1 and 2 Murray Rose Avenue, Sydney Olympic Park Modification 2

Design Changes to Building 1 and 2
State Significant Development Modification Assessment
(SSD 9403 MOD 2)
July 2023

Figure 3 | Northern elevation of Building 1: approved (above) and proposed (below) (source: SSD 9403 Approved Plans and Applicant's RtS)

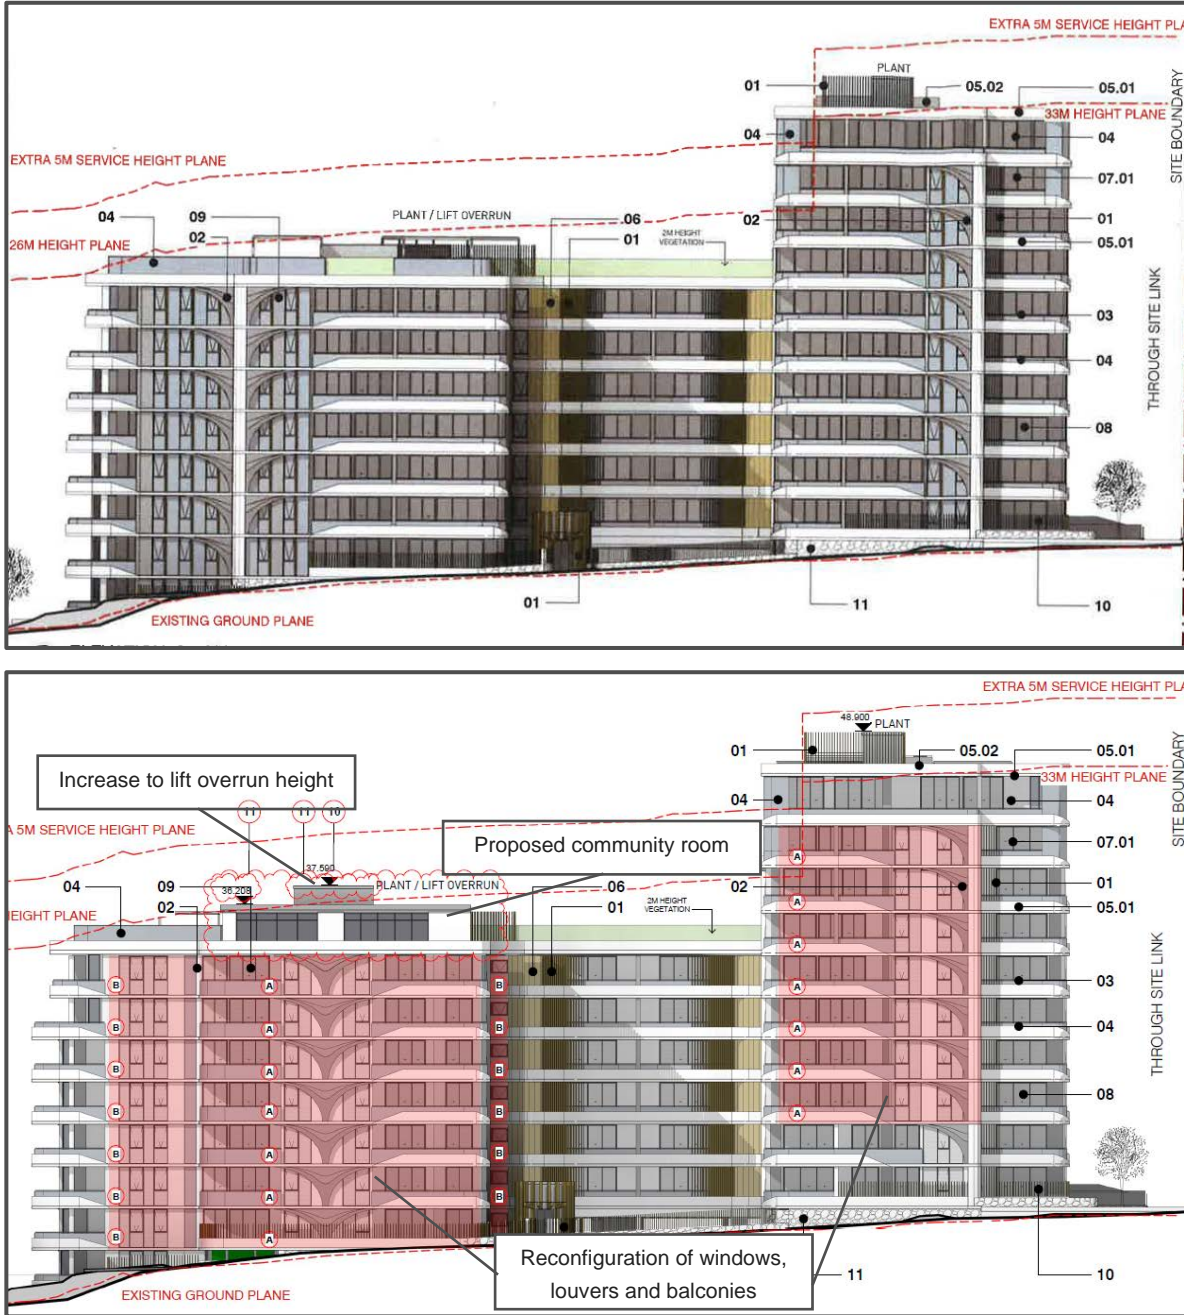
The subject modification seeks to make the following changes to the height of Building 1:

- increase the maximum building height from 35.5 m (RL 48.3) to 36.1 m (RL 48.9), resulting in a 0.6 m increase. The Applicant advised the increase in maximum height was to facilitate structural changes, including the thickening of concrete slab heights at each level.
- increase in the height of the lift overrun at Level 9 from RL 35.6 to RL 37.59, resulting in a 1.99 m increase. The Applicant advised the increase was required to facilitate the installation of the lift and meet requirements of the lift contractor (**Figure 3**).
- addition of an enclosed community room on level 8 with a maximum height of RL 36.2 (**Figure 3**).

The Department considers the proposed increase in height to be acceptable as:

- the 0.6 m increase in maximum height to Building 1 to 36.1 m (RL 48.9) is minor, representing an increase of 1.69% of the approved building height
- the increase in maximum height to Building 1 is attributed to the thickening of concrete slabs and therefore would not significantly increase the bulk and scale of the building
- while proposal would result in an additional exceedance due to the increase in height of the lift overrun in Building 1, it would remain below the additional 5 m rooftop service zone permitted by the Sydney Olympic Park Master Plan (2018 Review)

Figure 5 | Northern elevation of Building 2: approved MOD 1 (above) and proposed (below) (source: SSD 9403 MOD 1 Approved Plans and Applicant's Rts)

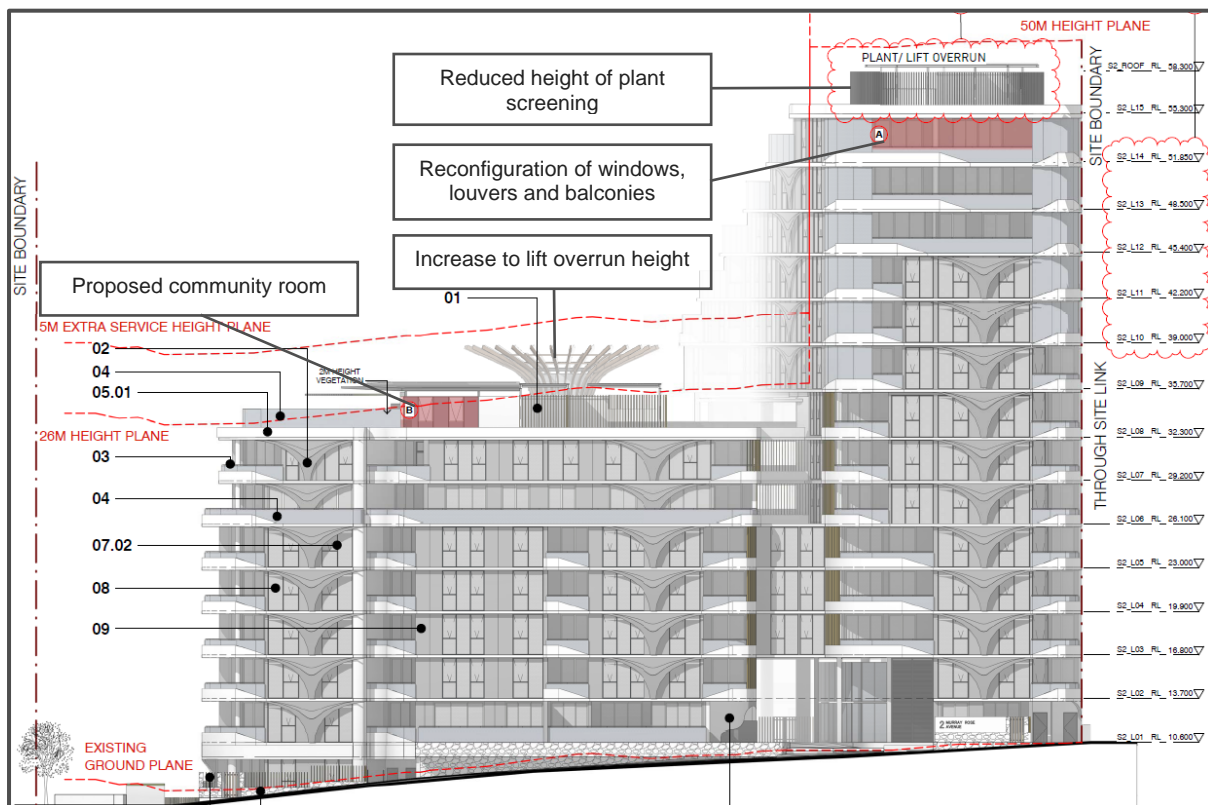
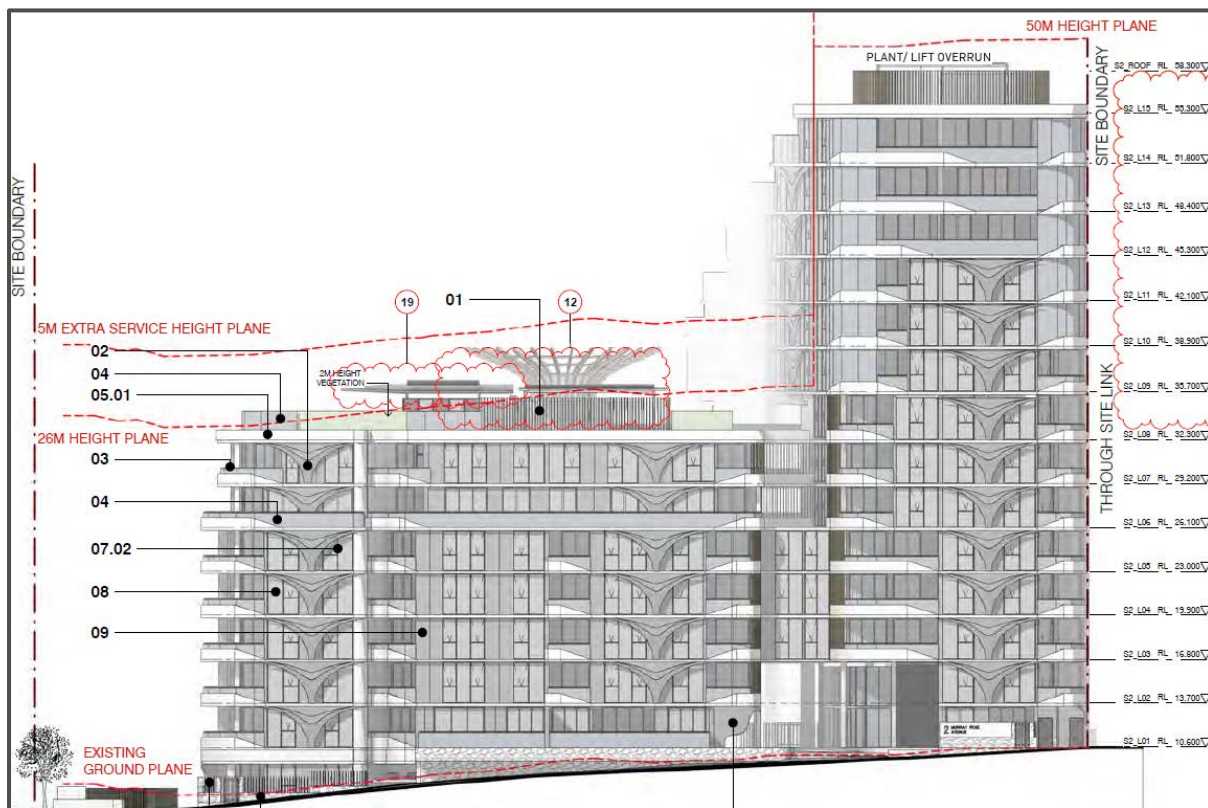
The subject modification seeks to make the following changes to the building height of Building 2:

- increase the height of the lift overrun/plant at Level 09 of Building 2 from RL 37.00 to RL 37.35, resulting in a 0.35 m increase (**Figure 5**).
- increase in heights of Levels 10 – 14 to accommodate the thickening of concrete slabs. Levels 10 – 13 are proposed to increase by 0.1 m, and Level 14 by 0.05 m. No change is proposed to the approved maximum height of RL 58.30 (**Figure 5**).

- the proposed 0.35 m increase in height of the lift overrun in Building 2 is minor and would remain below the additional 5 m rooftop service zone permitted by the 2018 Review

Figure 7 | Site 1: Extent of height variation: approved (left) and proposed (right). Source: Applicant

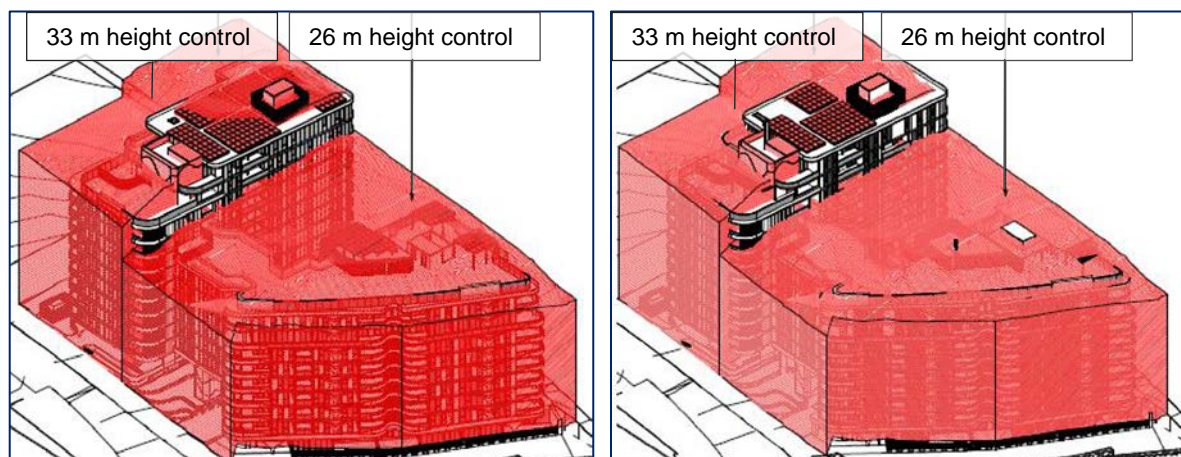
A comparison of the approved and proposed height increases on the height variation is shown in **Figure 7**.

Figure 8 | Site 2 Extent of height variation: approved (left) and proposed (right). Source: Applicant

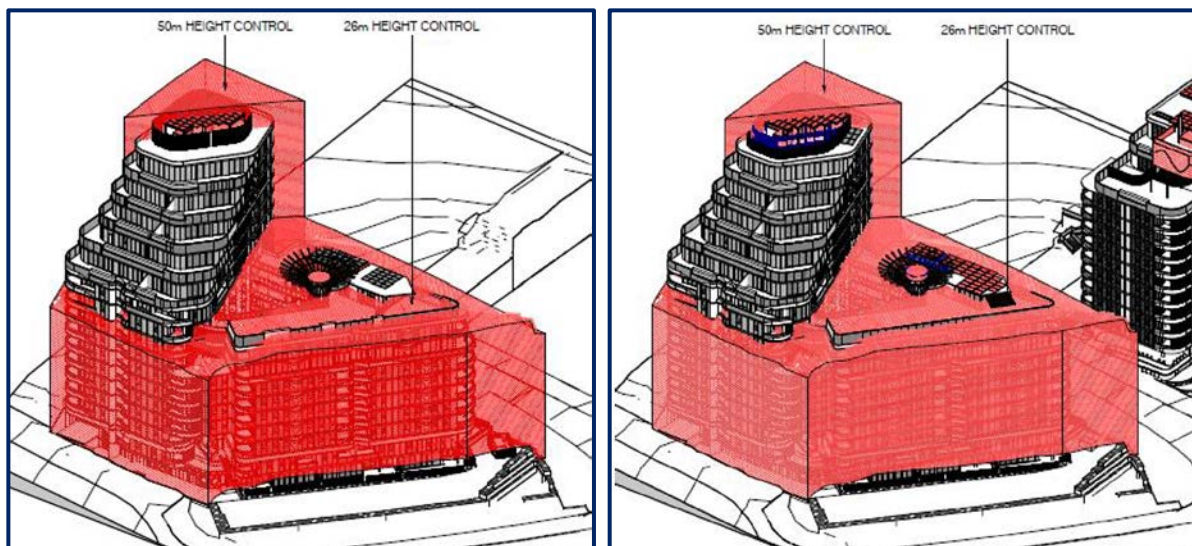
A comparison of the approved and proposed height increases on the height variation is shown in **Figure 8**.

While SOPA did not object to the proposed increase in height, concerns were raised regarding the impact of additional overshadowing to the Badu Mangrove Wetlands to the east of the site. This matter is discussed further in **Section 5.3**.

Figure 9 | Shadow diagrams for 21 June at 2 pm (left) and 3 pm (right) with the approved shadow extent outlined in blue and any additional shadow resulting in yellow. Source: Applicant.

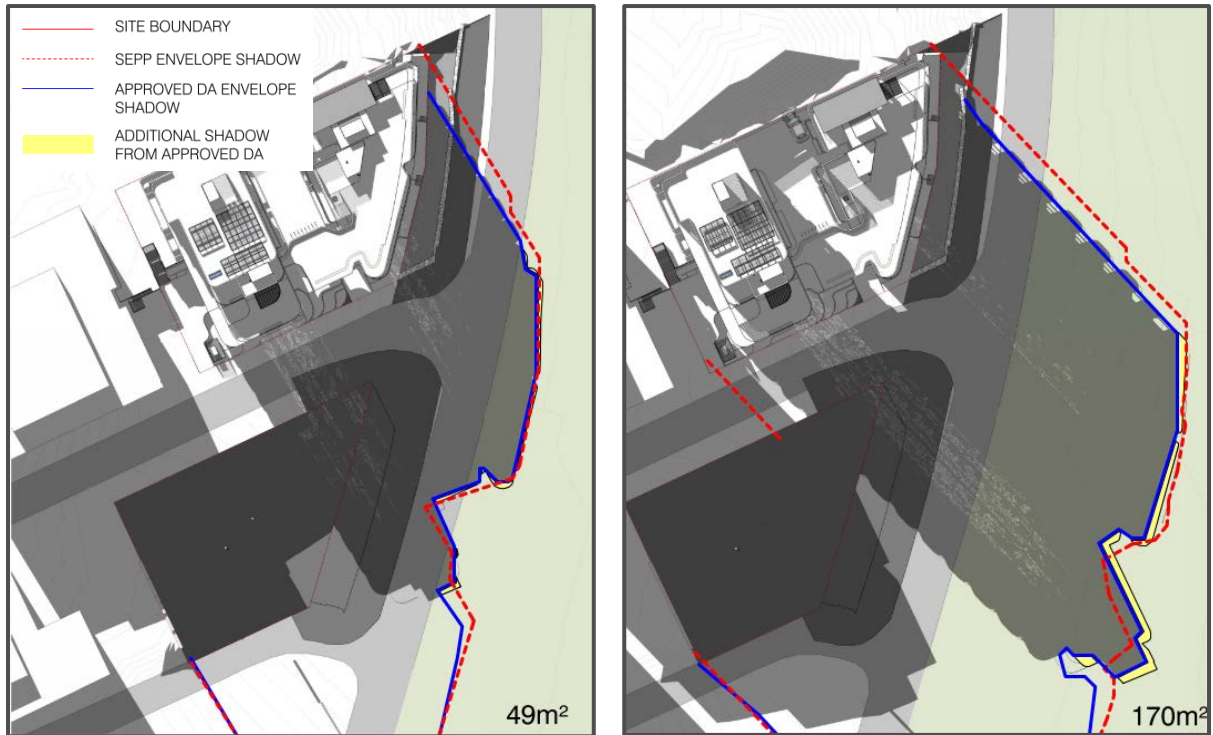
The greatest extent of overshadowing to the Wetlands from the approved building envelopes (as modified) was determined to occur at 3 pm in June and would result in approximately 0.64 ha of shadow. The Biodiversity Development Assessment Report (BDAR) submitted with the approved development determined it would result 0.7 ha of overshadowing onto the Bennelong Pond and the mangroves on the western edge during the Winter solstice between 2 pm – 3 pm. The BDAR noted that much of the affected area is already subject to shadow from existing vegetation.

Figure 10 | Shadow diagrams for 21 June at 2 pm (left) and 3 pm (right) with approved shadow extent outlined in green and the area of reduced shadow circled in navy. Source: Applicant.

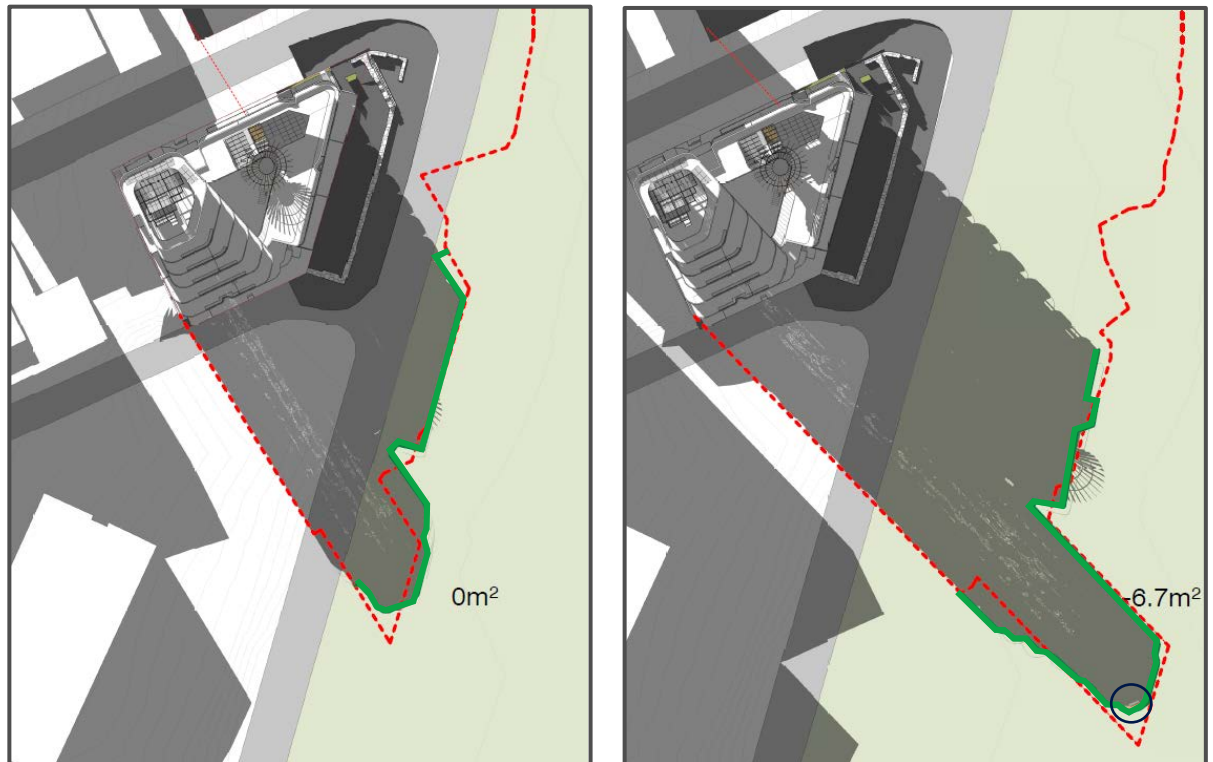
The Applicant advised the increase in height of Building 1 would result in 170 m² of additional overshadowing to the Mangroves during the Winter solstice between 2 pm – 3 pm (**Figure 9**). While the reduction in the height of plant screening on Building 2 would result in 6 m² less overshadowing to the Mangroves during the Winter solstice between 2 pm – 3 pm than previously approved (**Figure 10**).

SOPA raised concern with the lack of information into the wetland, the nature of the estuarine communities affected or the impact to the estuarine community. Additionally, SOPA noted that none of the mitigation measures proposed address shadow impact.

- the proposed modification would increase the maximum extent of overshadowing from 0.64 ha to 0.66 ha at June 3 pm, representing an increase of 0.02 ha
- the original assessment considered a larger overshadow area of 0.7 ha, as the figure was rounded up from an area calculation undertaken at a broader scale
- the ecological integrity of the wetland area would be retained due to the small area that would be affected, the temporary nature of the overshadowing and the existing shadow over part of the area as a result of the trees lining Bennelong Pond
- while the Biodiversity Offset Scheme (BOS) can be used to offset indirect impacts that result in degradation of an ecosystem to the extent that it is no longer viable, in this instance this is not considered to be necessary as the proposed development is unlikely to impact the biodiversity values of the wetland area.

EHG supports the Applicant's argument that the extent of impacts was considered in the original assessment, which conservatively predicted a larger area of shadow cast (0.7 ha), and the modification is anticipated to result in approximately 0.66 ha. EHG noted there were errors in the BDAR submitted with the FRtS. As requested by the Department, the Applicant subsequently submitted a revised BDAR correcting these errors.
